Southland Regional Council (Environment Southland) Proposed Southland Water and Land Plan

Comments by:

Dr. Michael Sklash, Ph.D., P.Eng.

Objectives of My Analysis of Nitrate in Groundwater in the Wendonside Groundwater Zone

Groundwater Flow Map for the WGZ (Wilson et al., 2008)

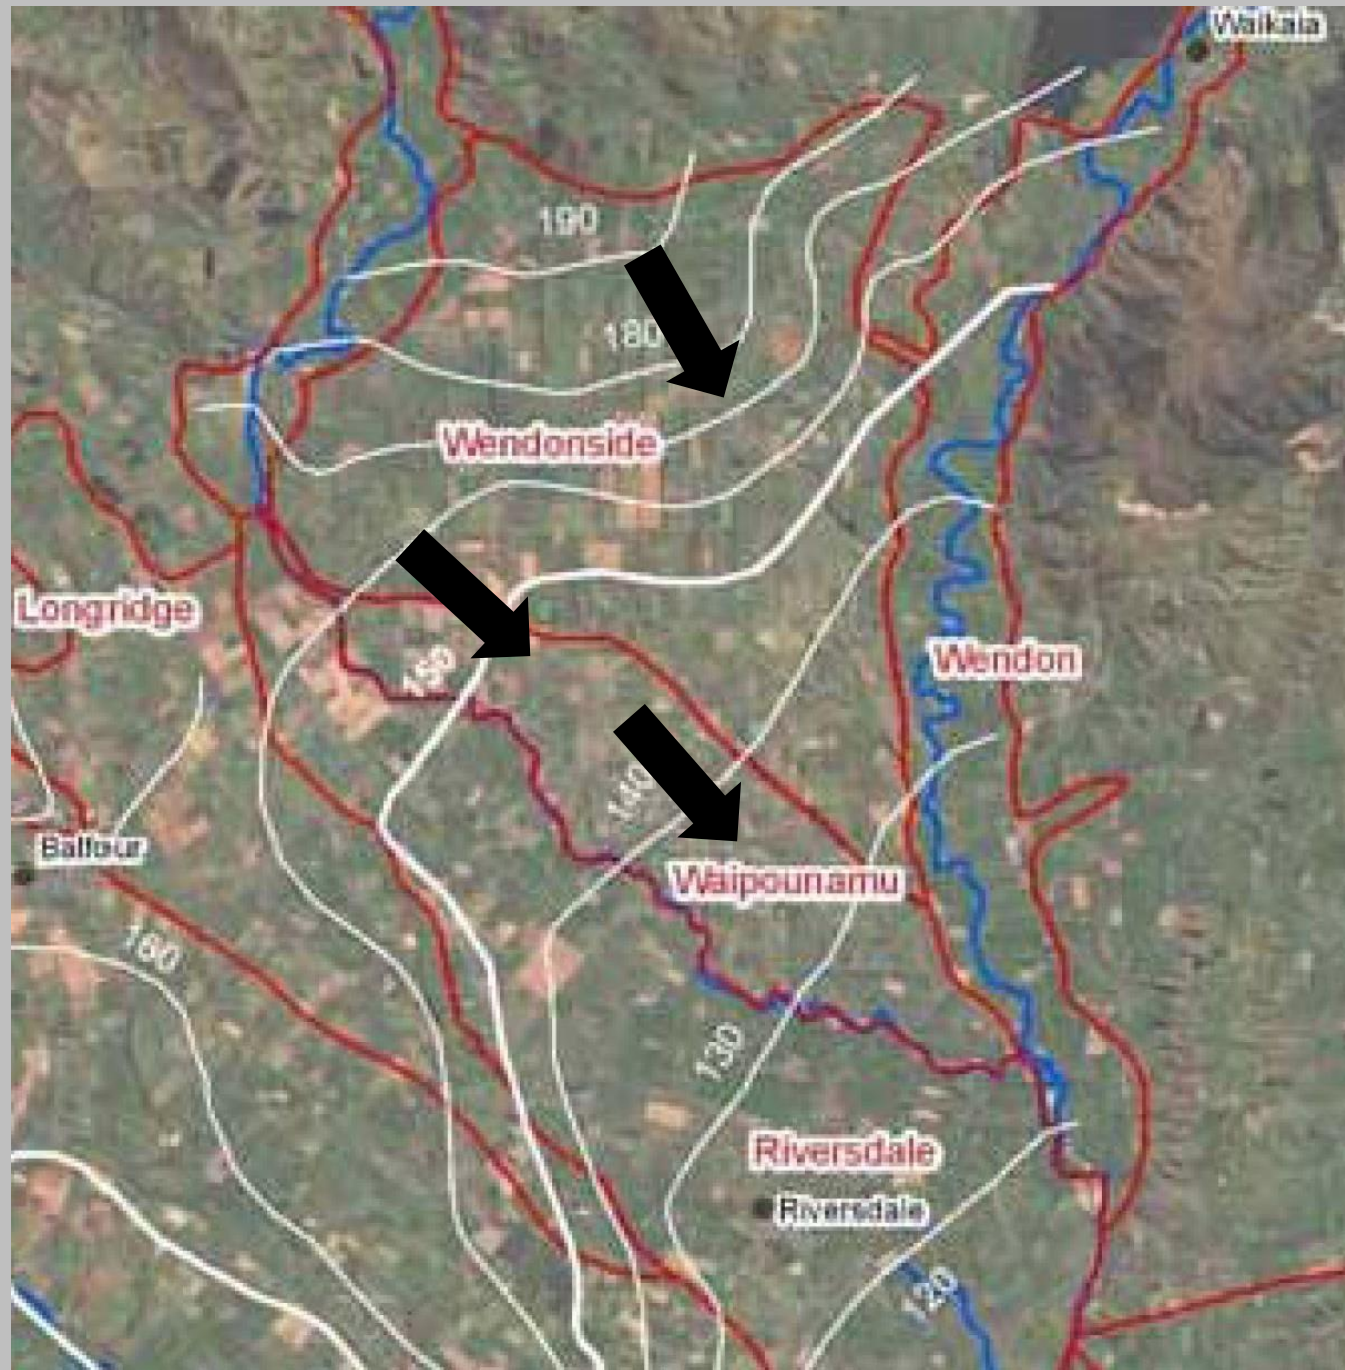
- Groundwater contours indicate that WGZ groundwater does not discharge into the Mataura River

Stream Gauging near WGZ (Hughes et al., 2011)

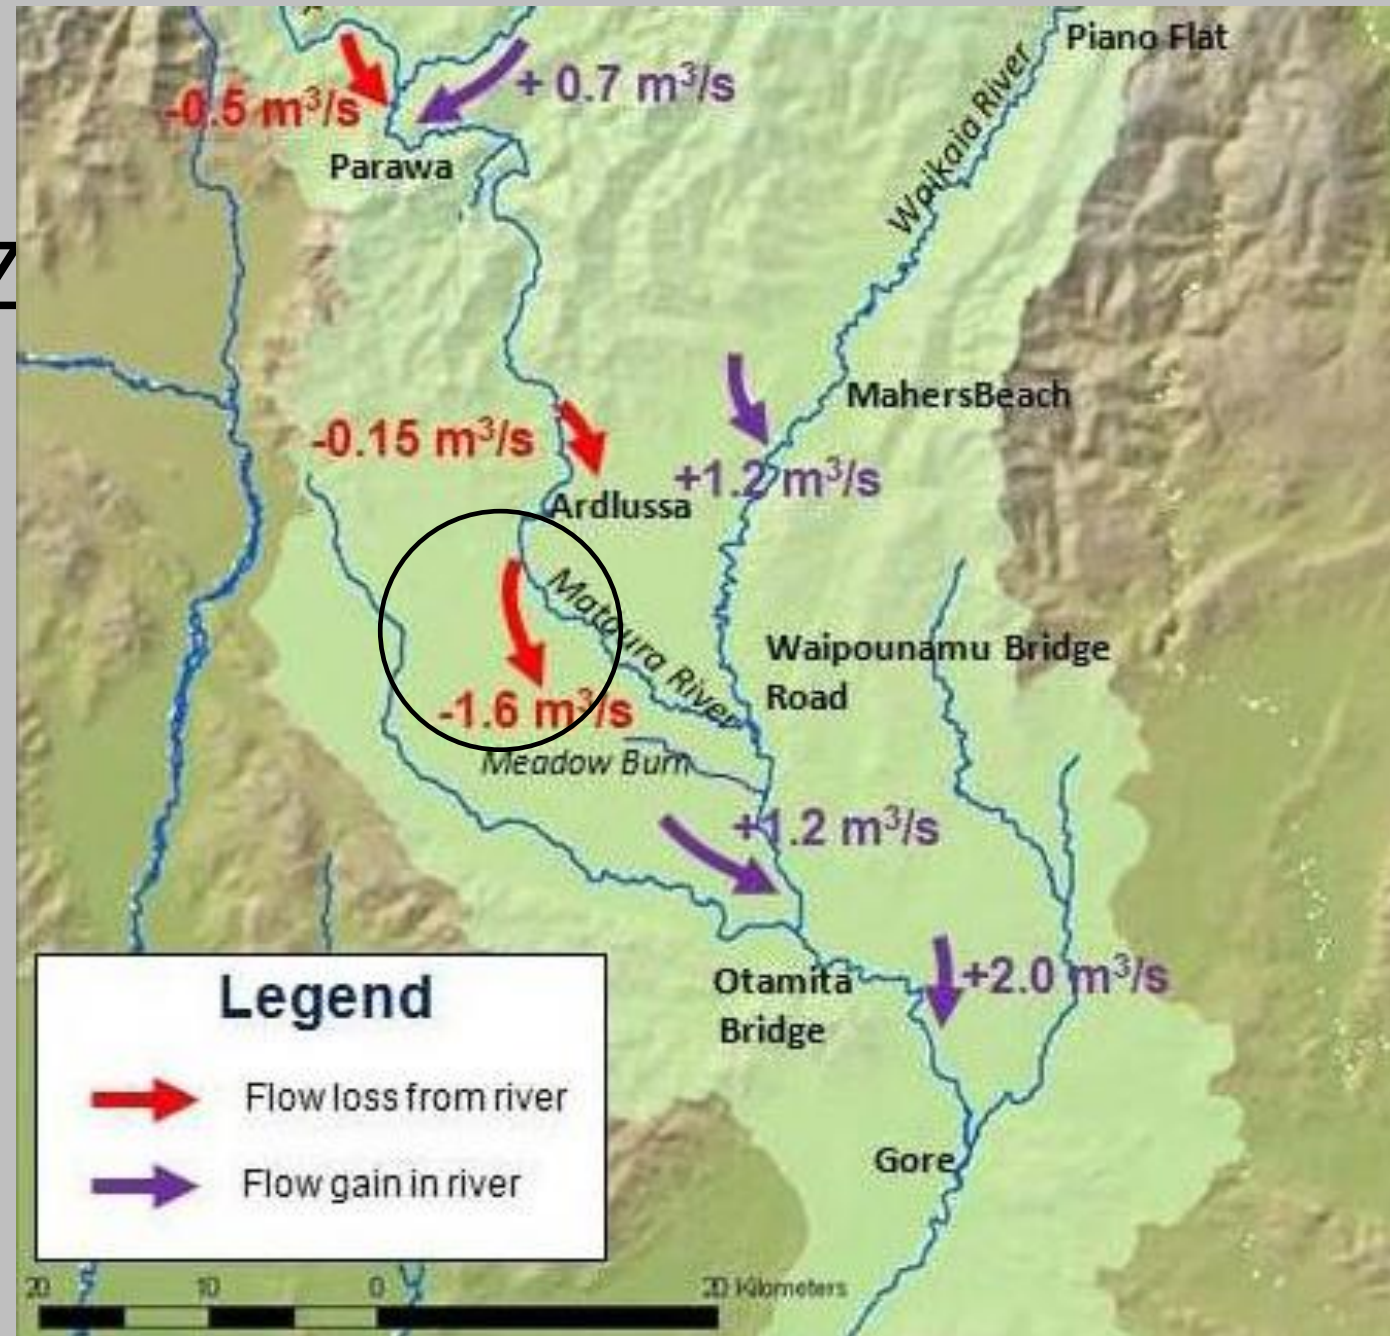
- Indicates WGZ groundwater does not discharge into the Mataura River

Nitrate Trends, State of Environment Wells

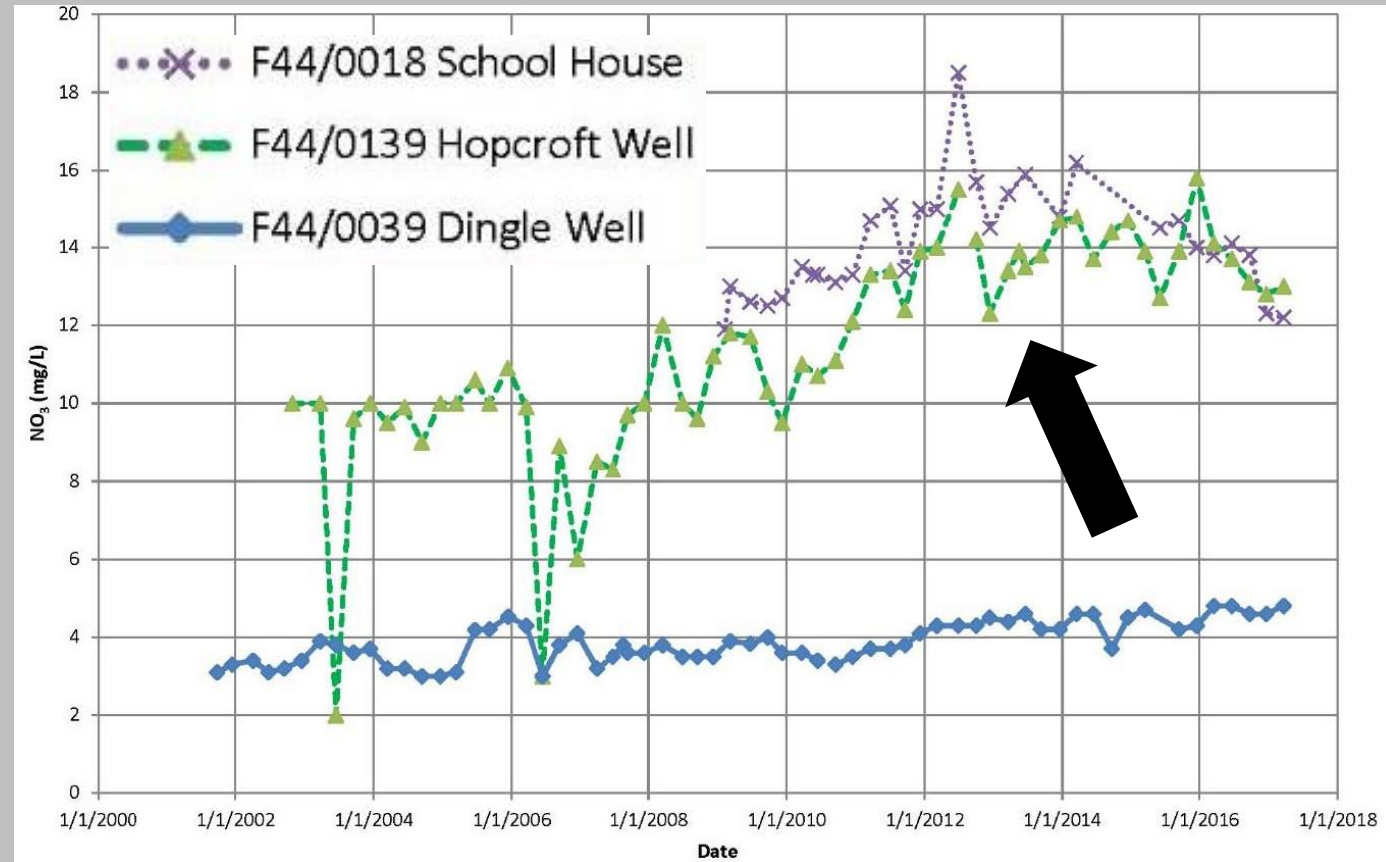
- Few long-term monitoring wells per aquifer
- Why did the trends change directions in ~2013?

Groundwater Residence Times in WGZ (Wilson et al., 2014)

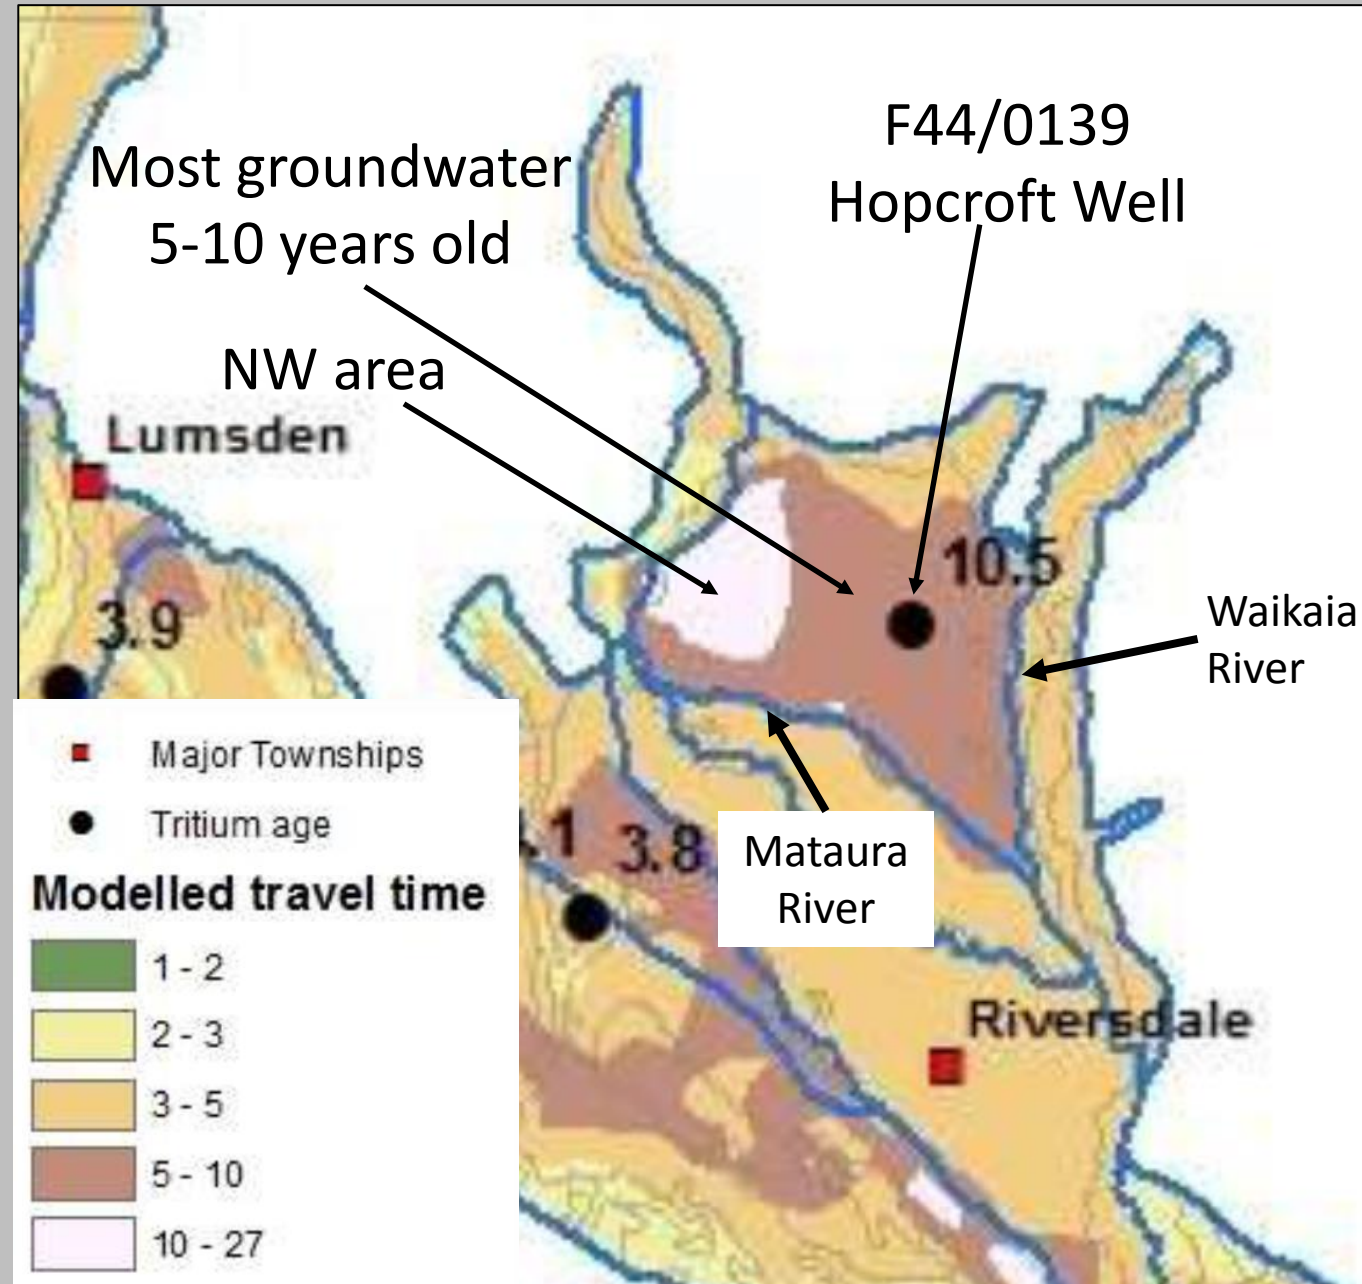
- How representative are nitrate data of current agricultural practices?
- Should same rules apply for different travel times?

The School House Well

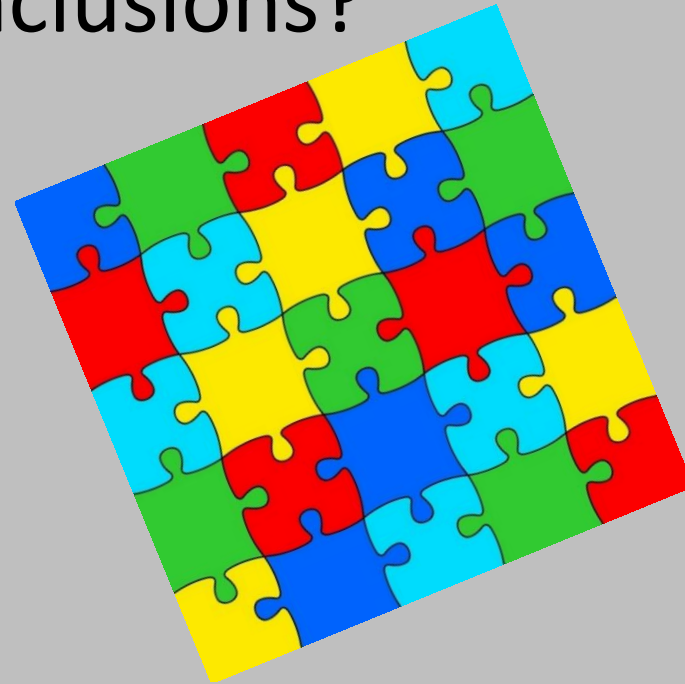
- Are these wells secure?
